# Rezoning Transportation Analysis

Petition Number: #2022-105

From: Jake Carpenter, PE

## Revision Log:

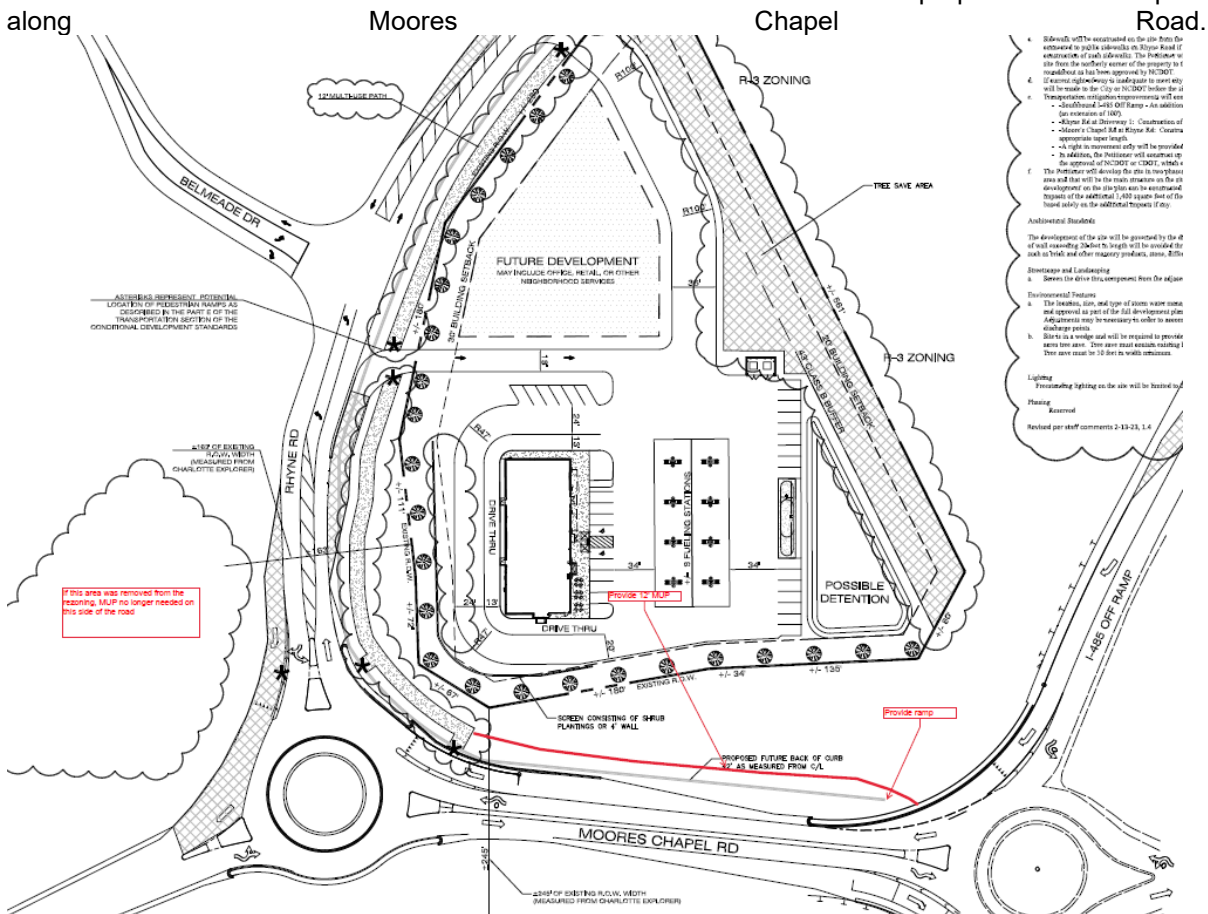
2. ~~**Outstanding Comment** Revise site plan conditional note in the transportation section letter e. for Southbound I-485 Off Ramp to say, "Extend existing southbound right turn lane to provide 400' of storage and appropriate taper."~~

**REWORD:**

Extend SBR to provide 400' of storage and appropriate taper.  
Existing SBR is 200'.

**Clarifying Comment from 12/22/2022:** Reword improvement at Southbound I-485 Off Ramp to what is shown in the picture above.
